CCK-2568-22

ADDENDUM # 4

CONSTRUCT/ IMPROVE GREEK HOUSING (DELTA GAMMA) Bid Package #2 – All Work Categories

UNIVERSITY OF KENTUCKY
 2555.0 Construct/Improve Greek Housing
 (Delta Gamma House)

2 VEHICULAR RATED CONCRETE AT DUMPSTER PAD
 SCALE: 1/4"=1'-0"

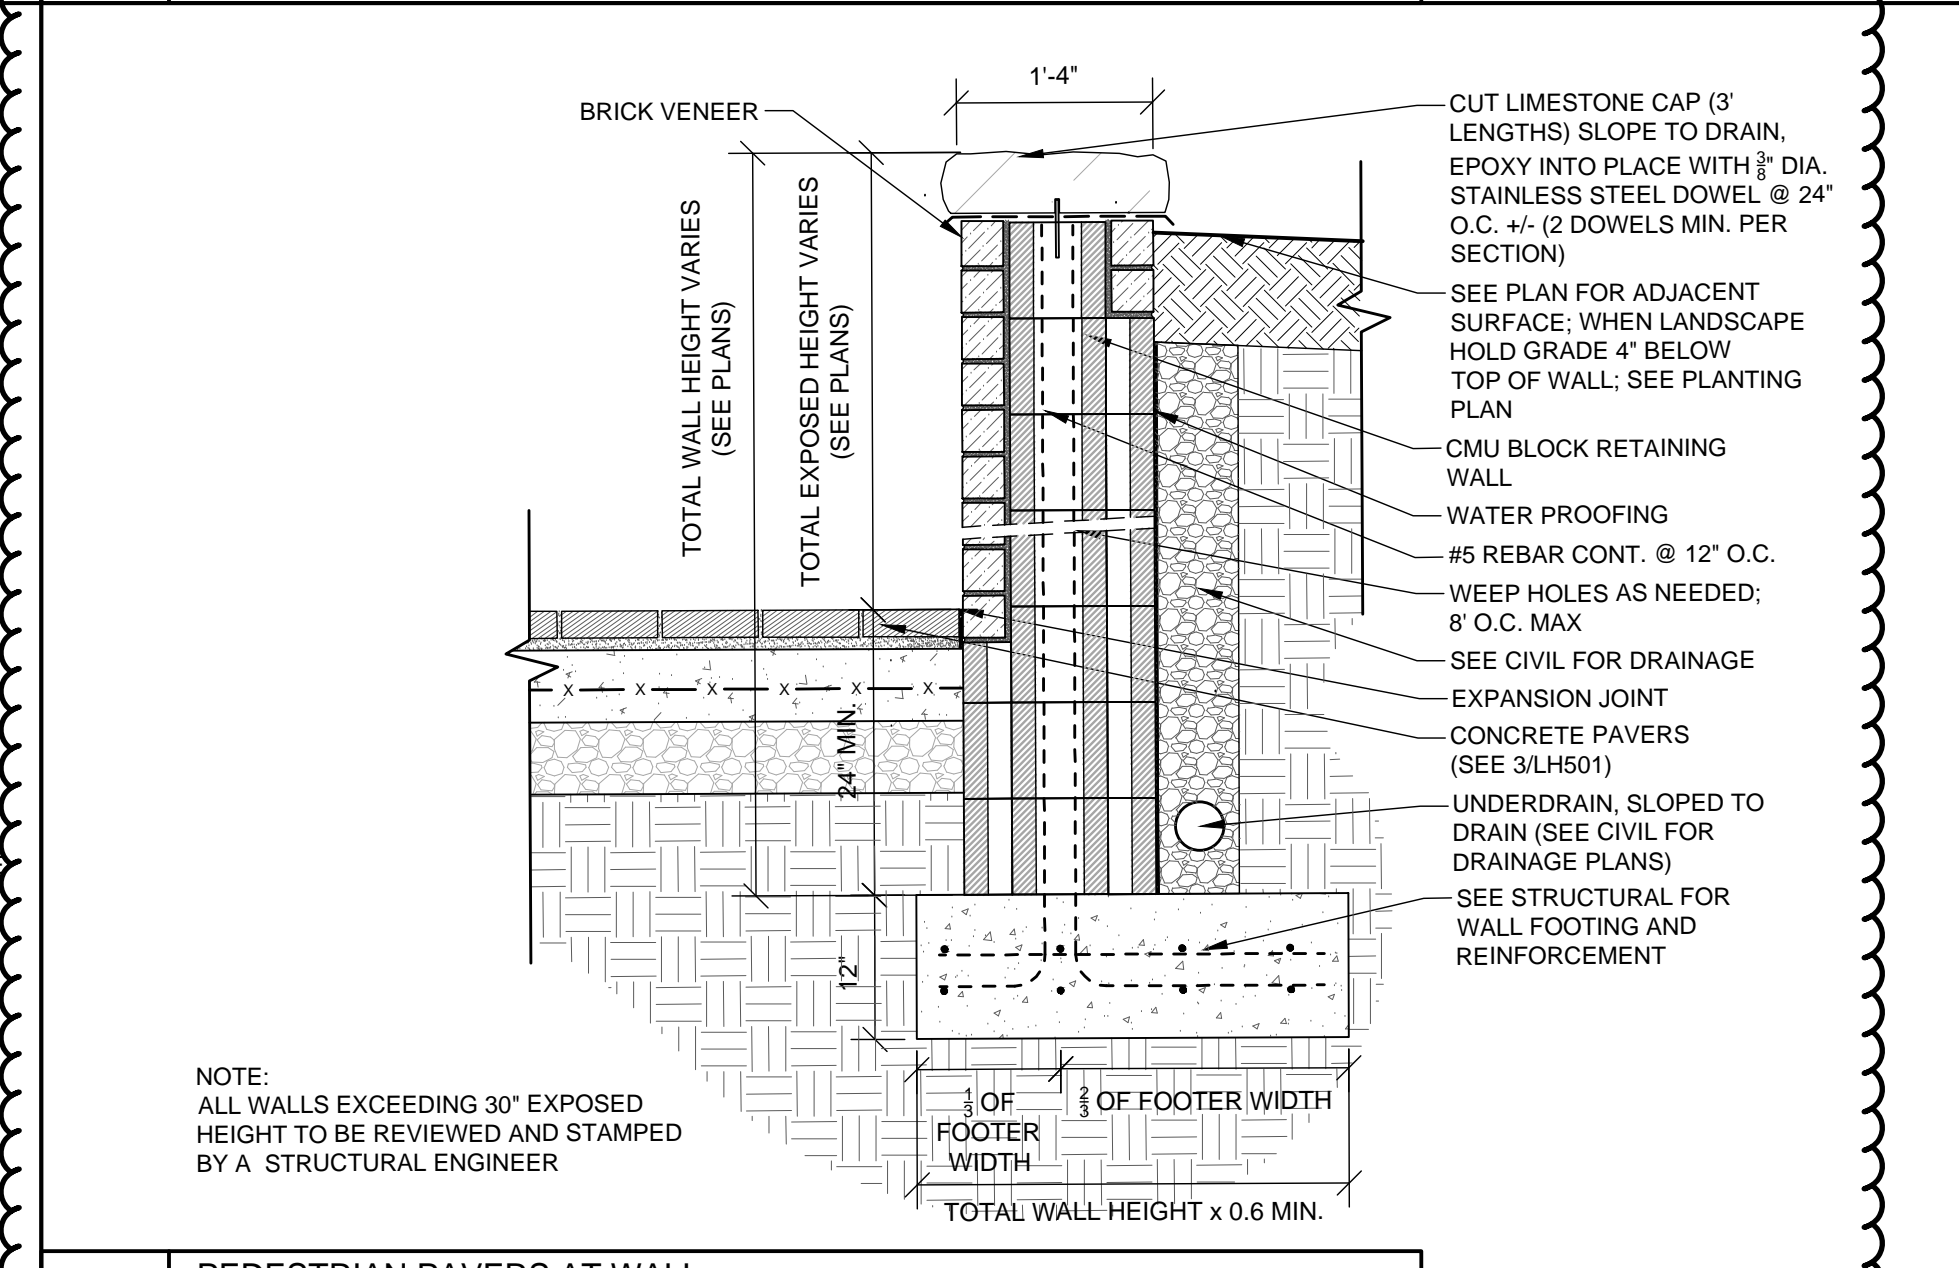
LH501	HARDSCAPE DETAILS	9/7/21
	<ul style="list-style-type: none"> • Wall detail labels and footings revised 	
LH502	HARDSCAPE DETAILS	9/7/21
	<ul style="list-style-type: none"> • Wall detail labels and footings revised 	
LH503	HARDSCAPE DETAILS	9/7/21
	<ul style="list-style-type: none"> • Wall detail labels and footings revised

SHEET TITLE
HARDSCAPE DETAILS
SCALE (UNO.)

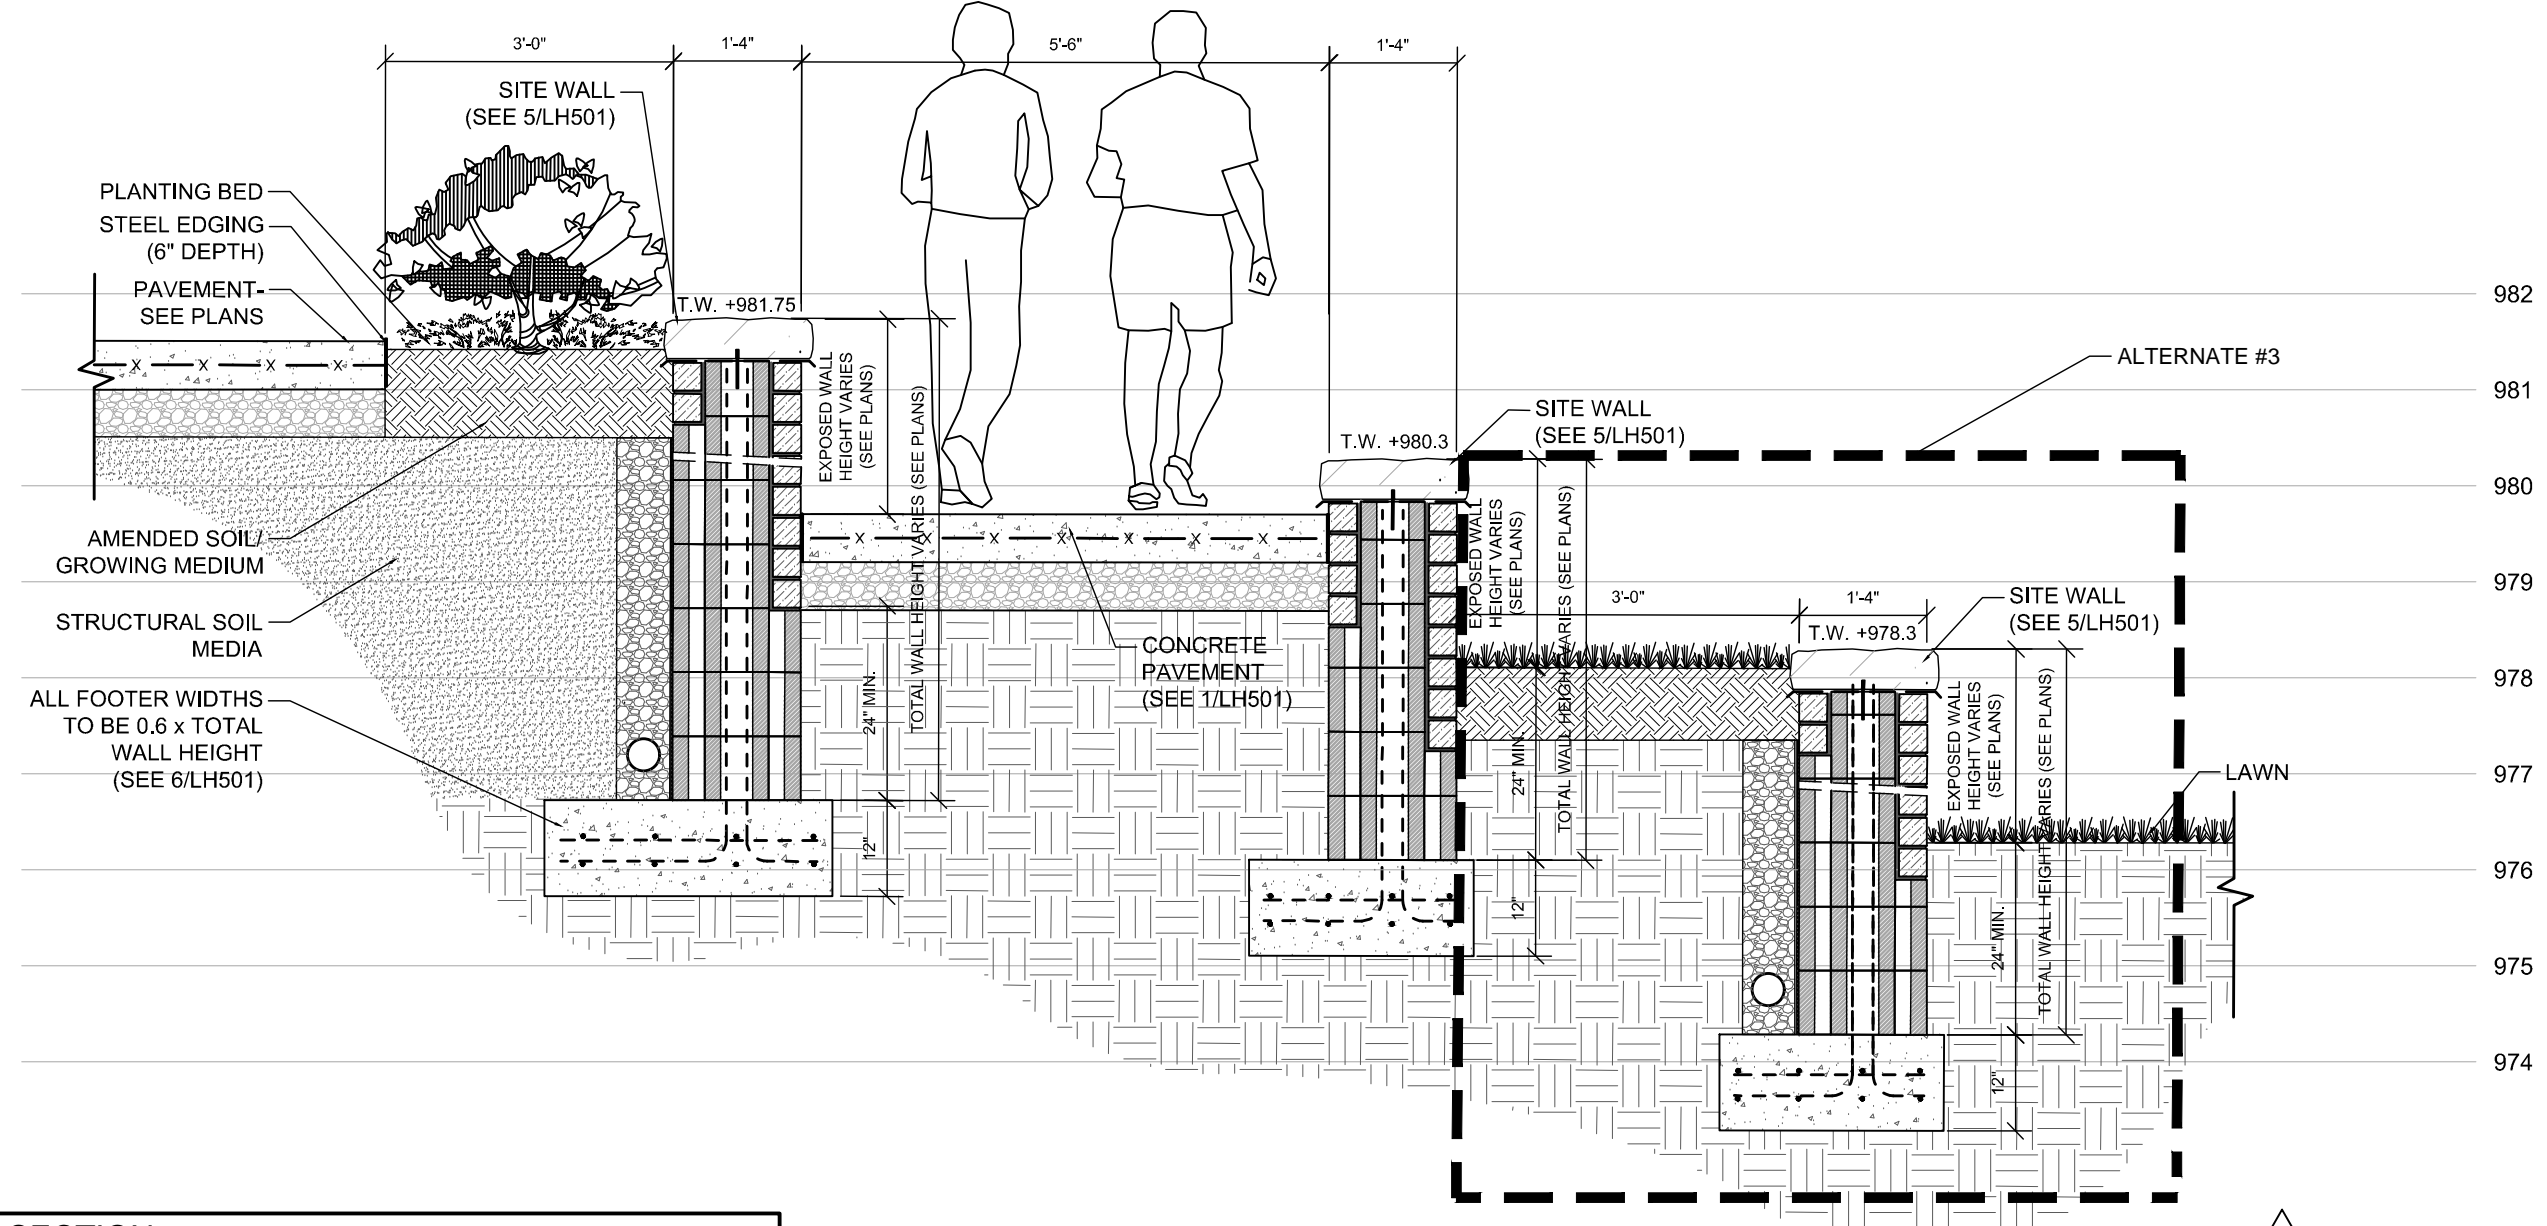
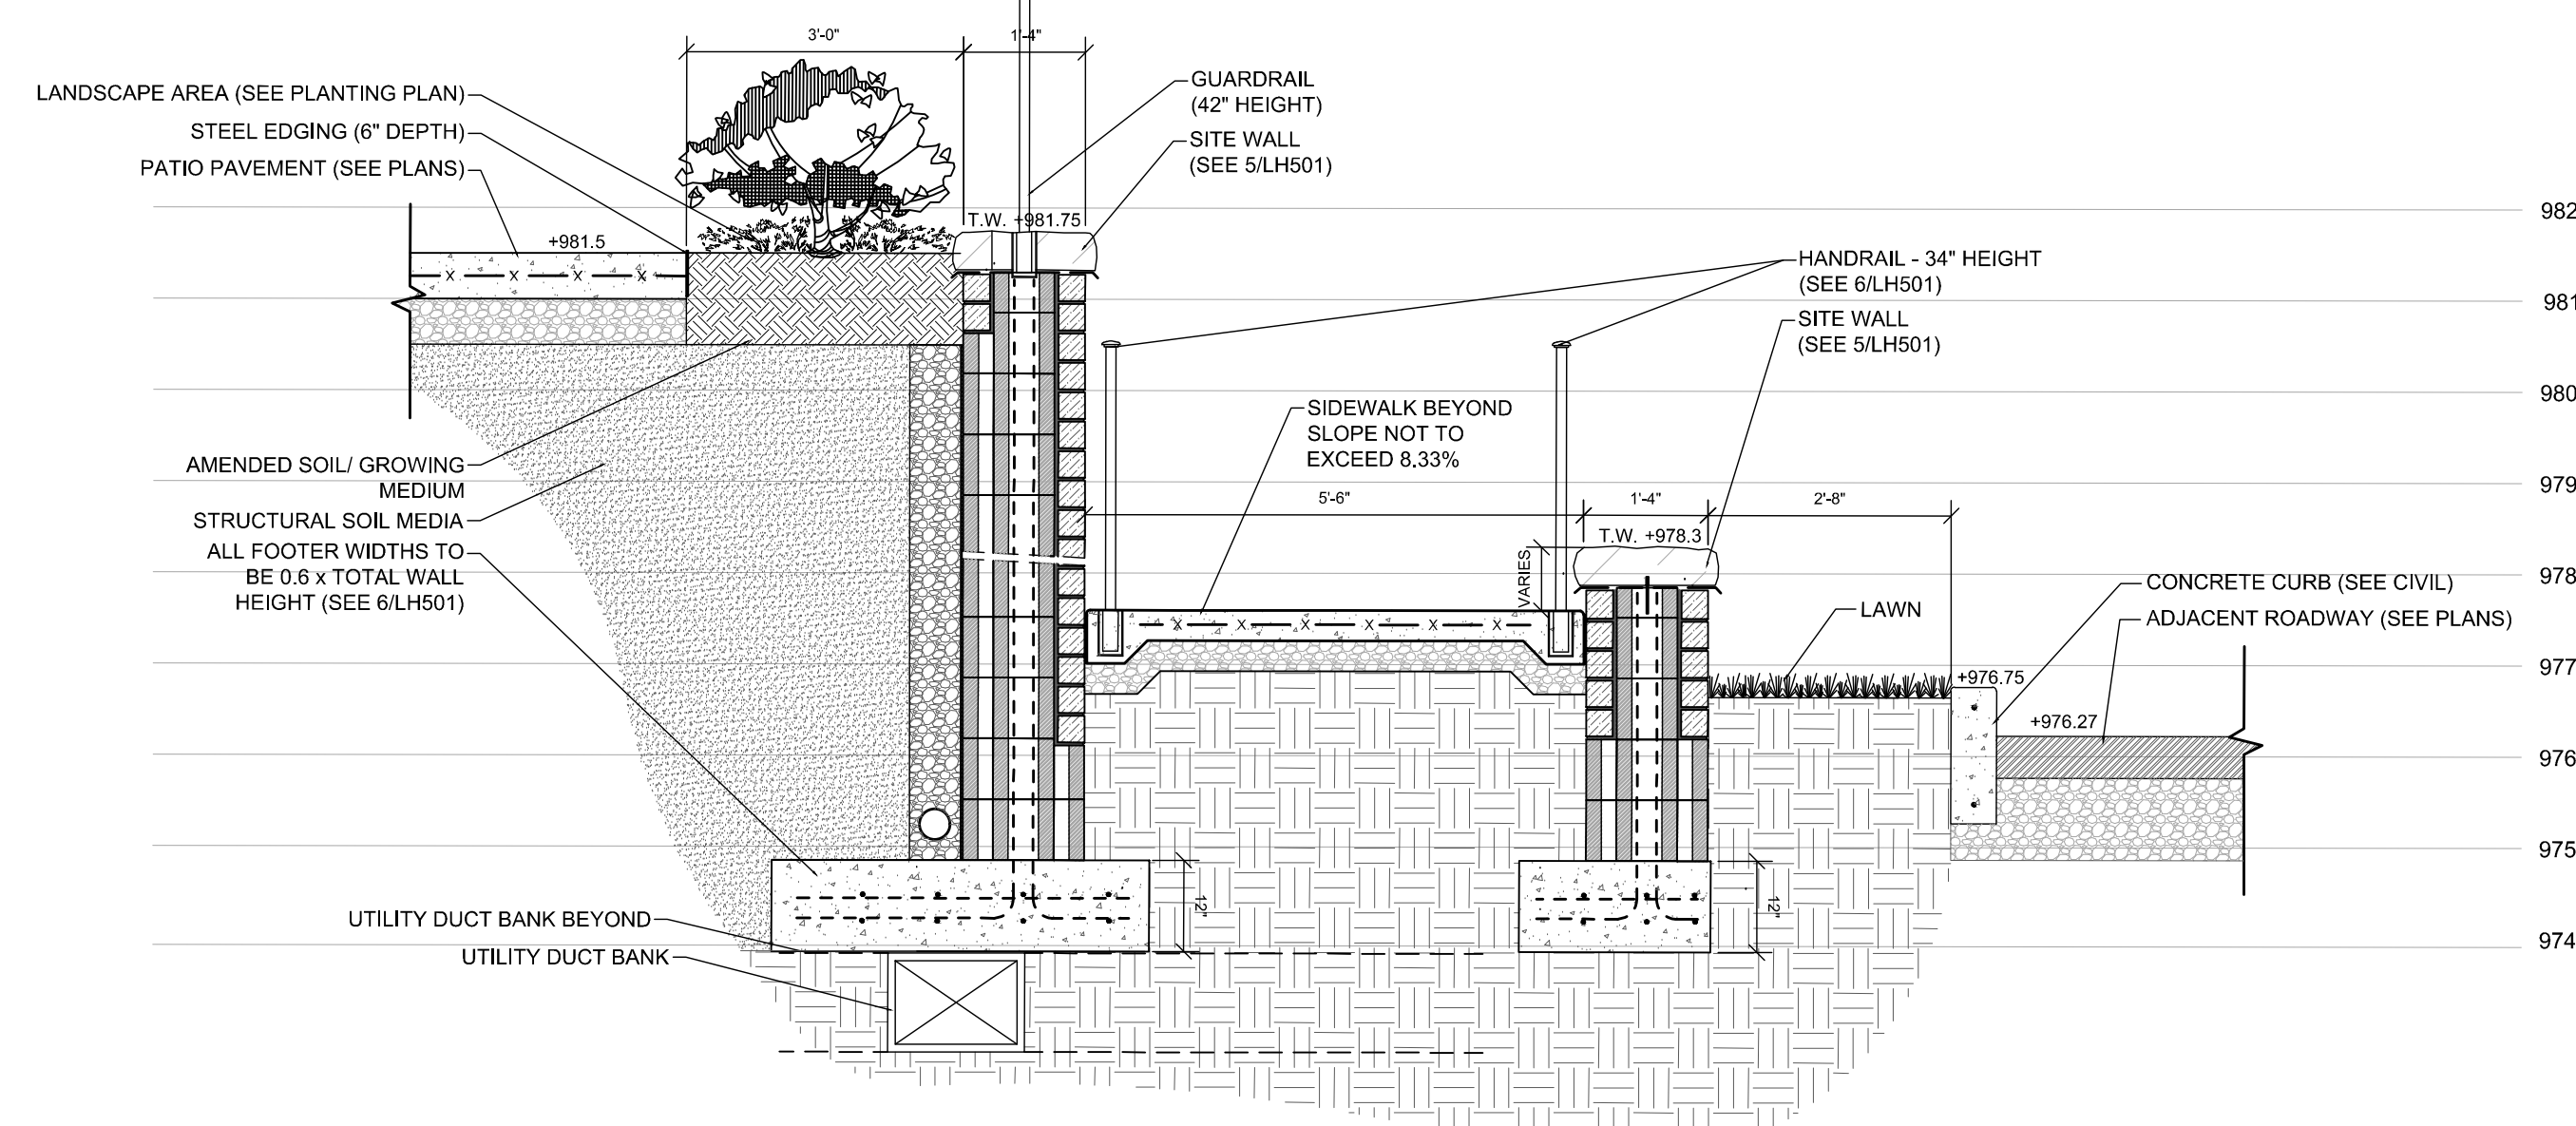
62.	We are bidding on the masonry portion on this project. On the site walls with the planters and ramp, can top of footer elevations for the site walls be given? I have a hard time believing that the excavation will go like what is shown on the sections on pages LH502. It seems like to me it'll end up all being at the lowest footer elevation since the walls are so close together. I feel like you'll end up undermining the footer/wall next to it if you try and step them as shown. It's showing 24" minimum depth for the top of the footer from the lowest grade/sidewalk. There is a lot of ambiguity with how much will actually be excavated and in turn how much CMU and brick will be needed this way. If the top of footing elevation is given, I think it'll give a way to get a more accurate number for these site walls and be less confusion in the future. Please let me know how to proceed with the bidding.	Top of wall elevations and grade elevations have been provided on the drawings. Maximum footer depth for the site walls has been set by the assumed elevation of the existing duct bank. LAS will review footer depths and will revise Sheet LH502 with the final Addendum.
